ADMINISTRATIVE AMENDMENT

MARKANA APARTMENTS - II
SAN PEDRO AND ALAMEDA
Albuquerque, New Mexico

Amendment 04/22/2021:
Increased building height;
consistent with the RM-H Zone
As Built - Parking Count Revised
August 19/2020

A1.10
SITE PLAN
FOR BUILDING PERMIT

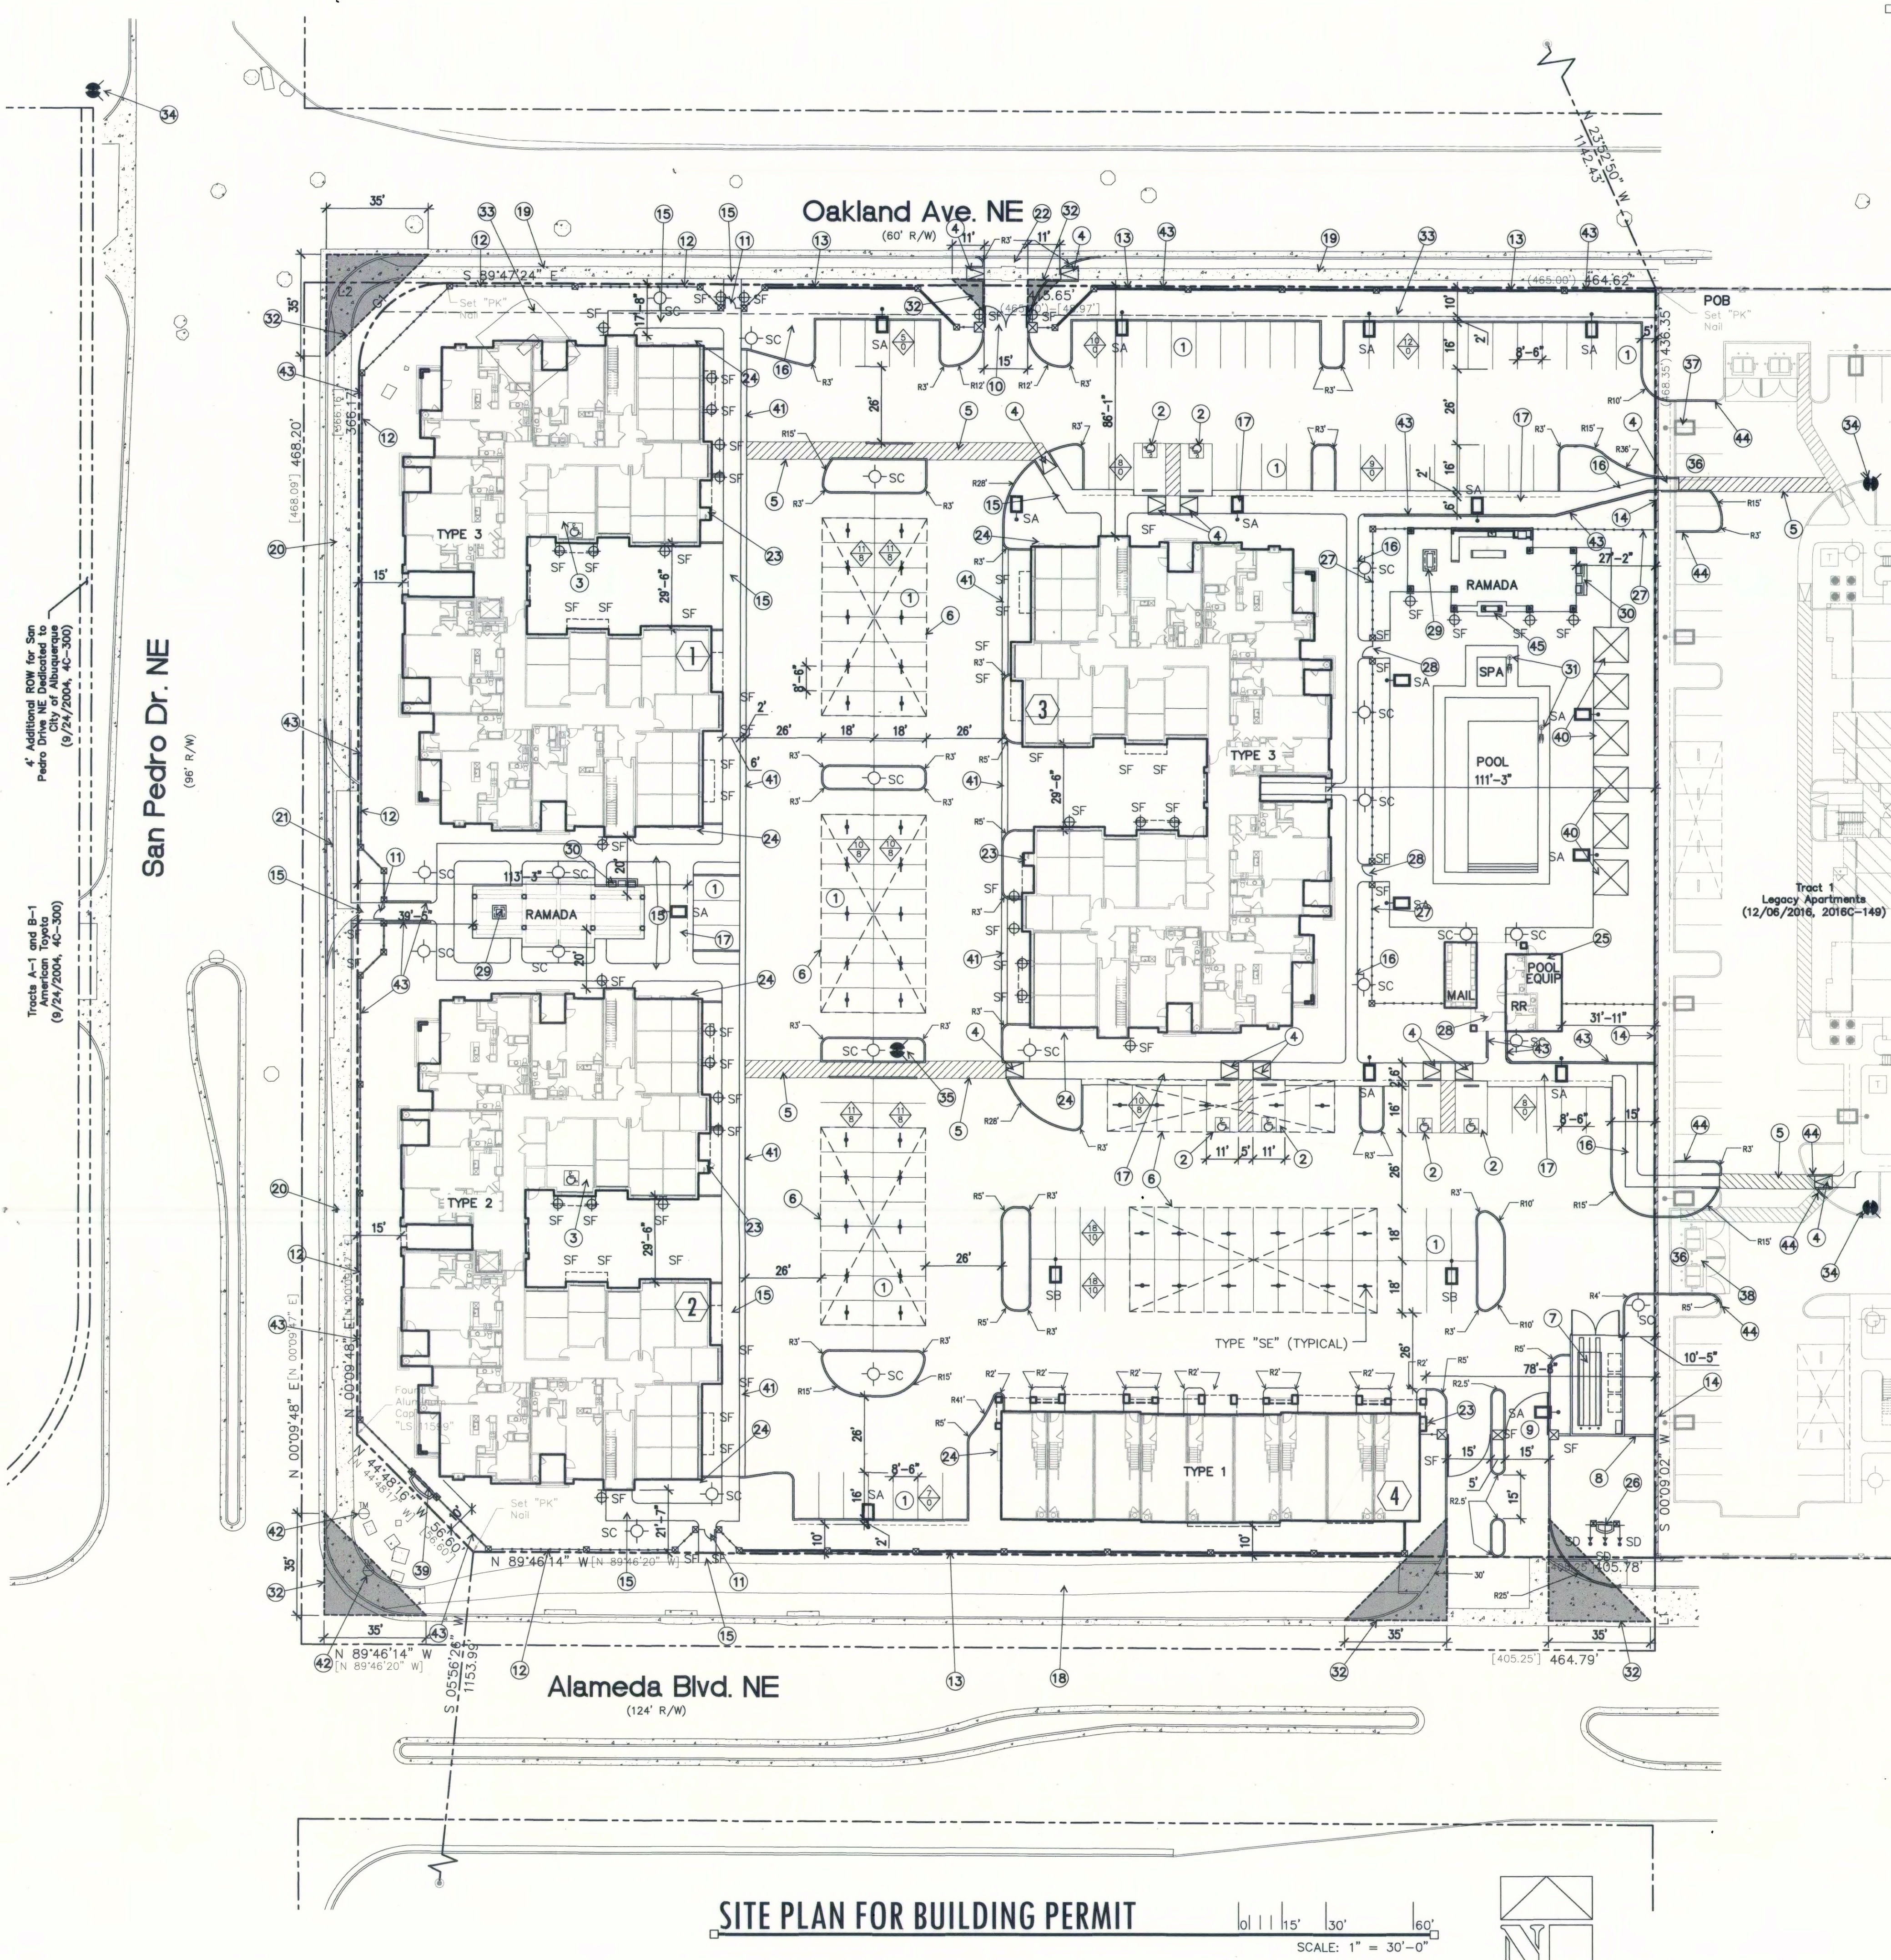
ADMINISTRATIVE AMENDMENT
FILE # 00834 PROJECT # 001280
Pricing calculation adjustments as shown.
See also SI-2020-00829.
RBrito 16 Sept 2020
APPROVED BY DATE

BUILDING TYPE 2 AND 3
ELEVATIONS

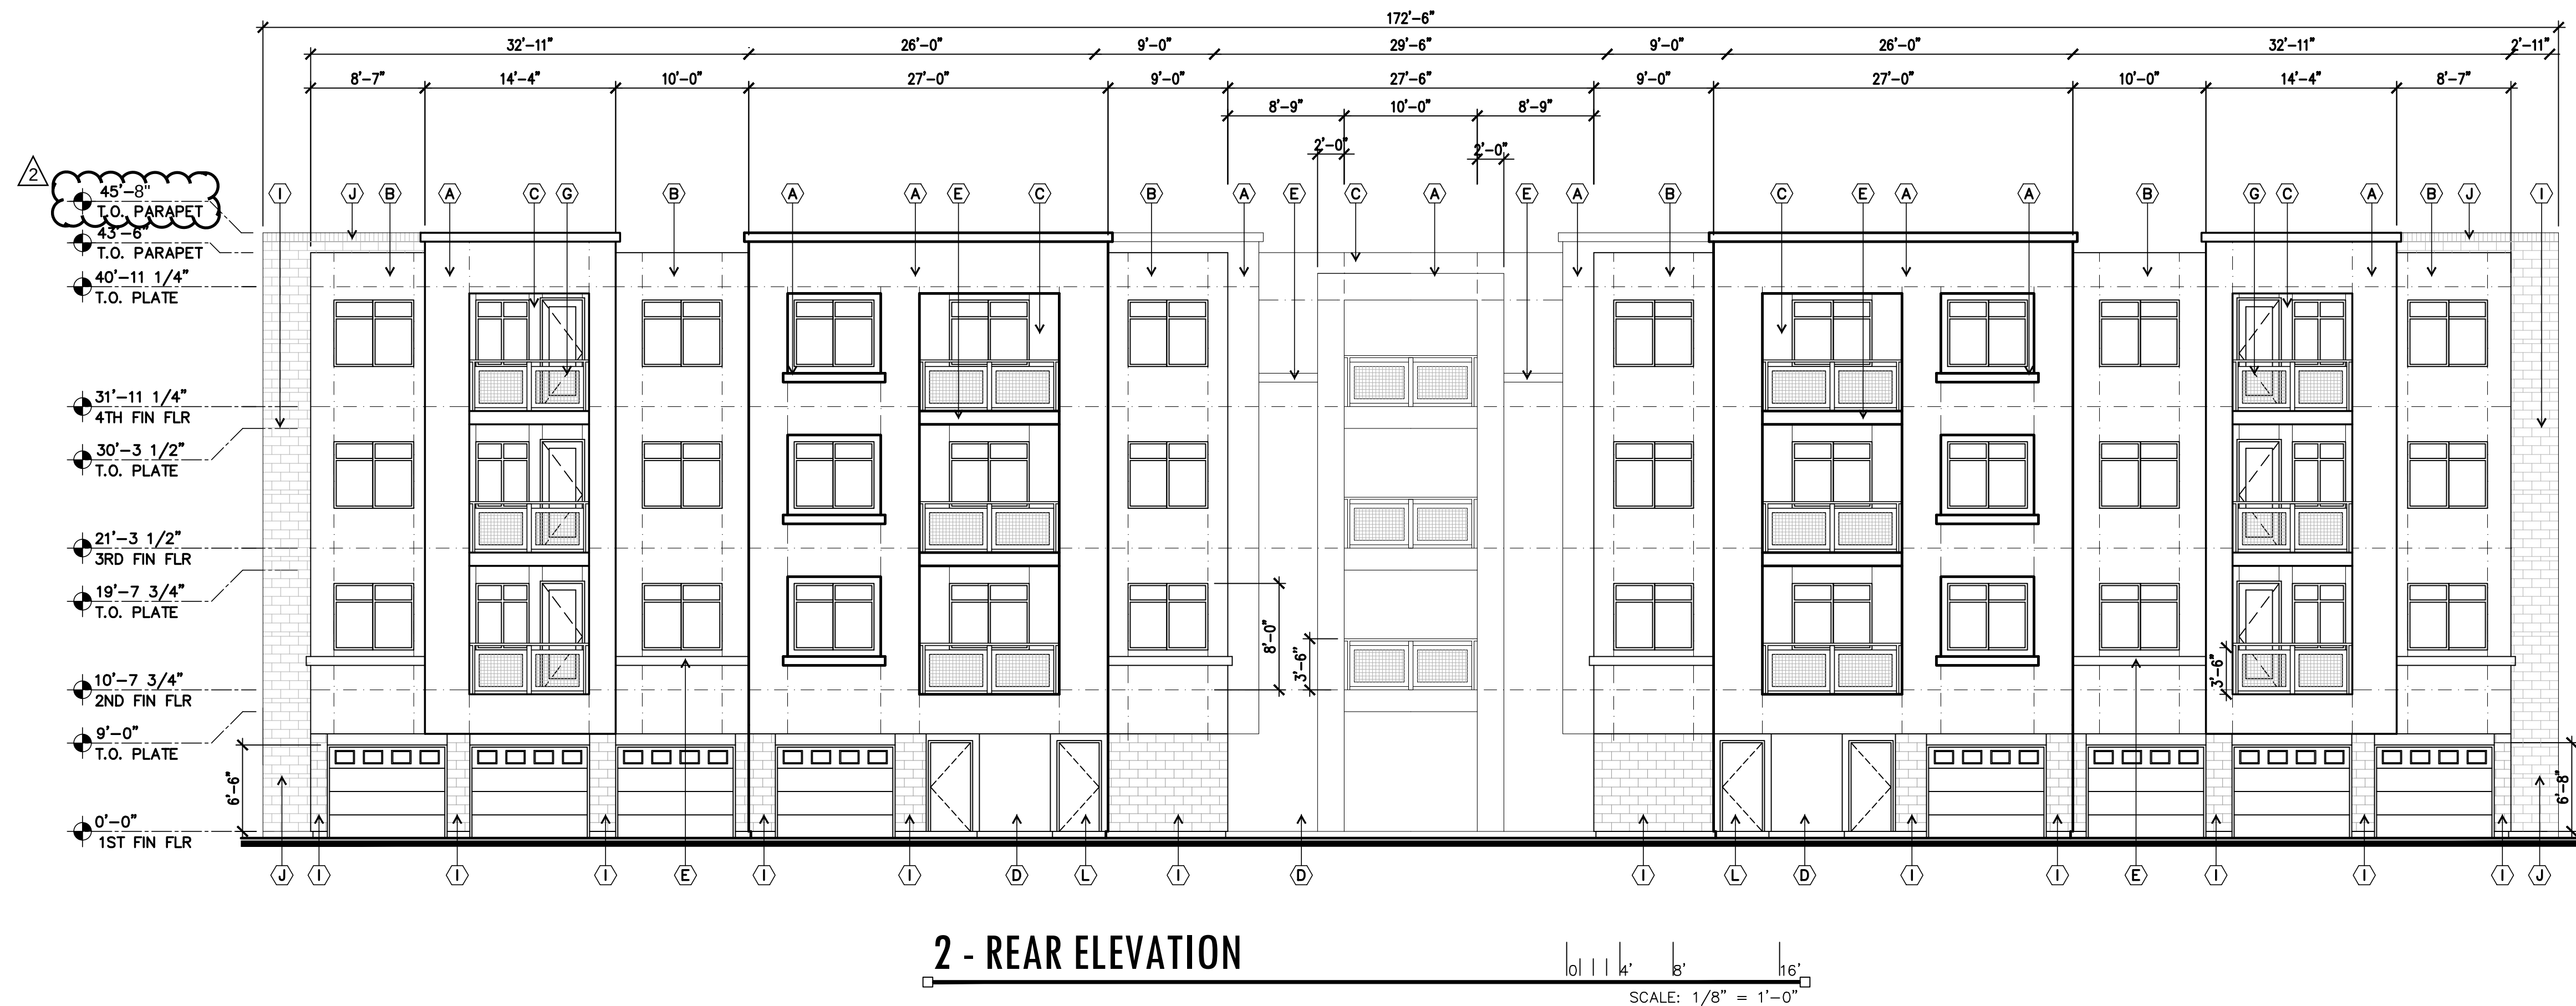
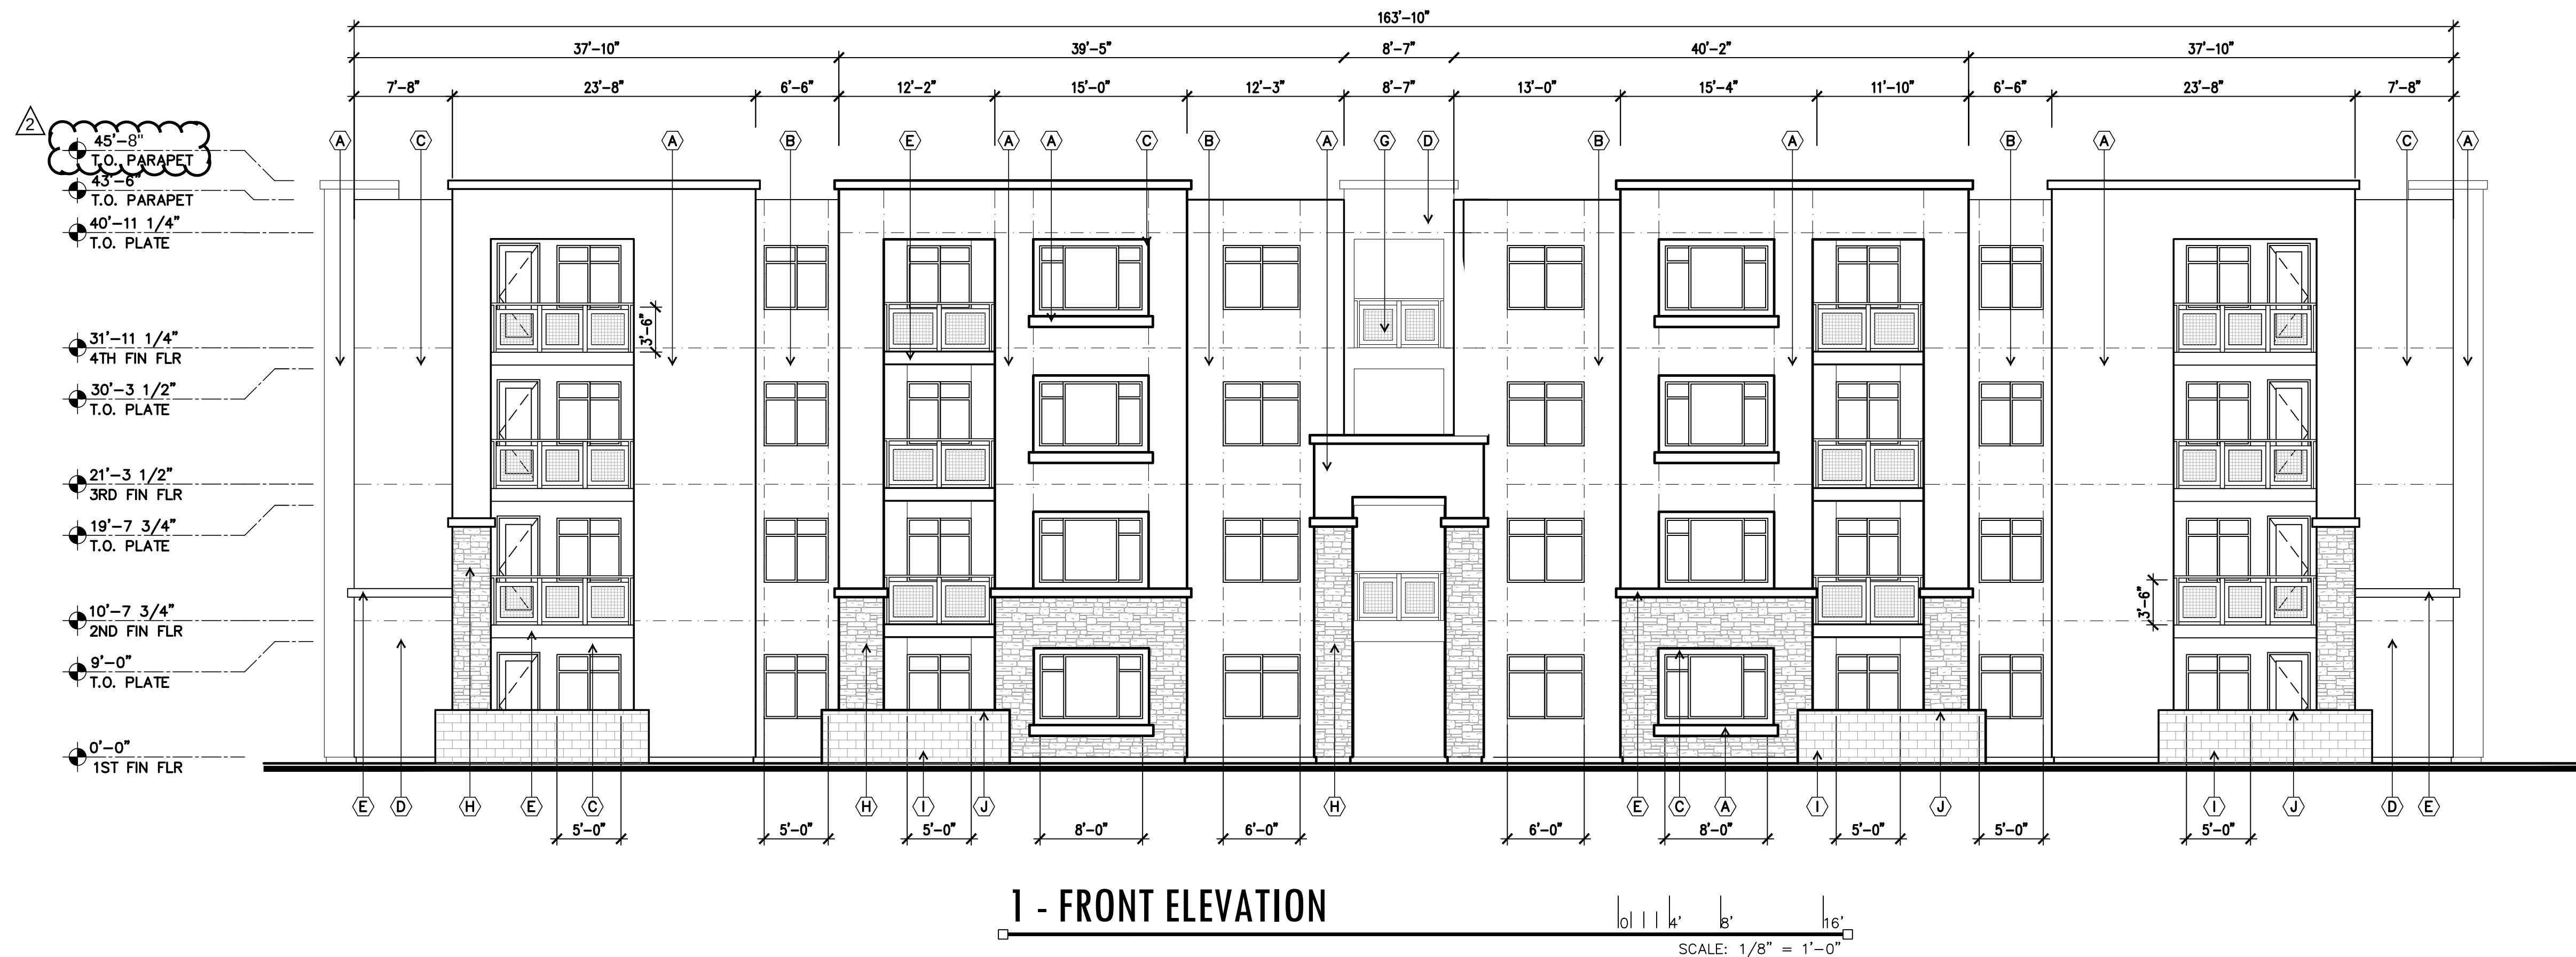
Amendment 04/22/2021:
Increased building height;
consistent with the RM-H Zone
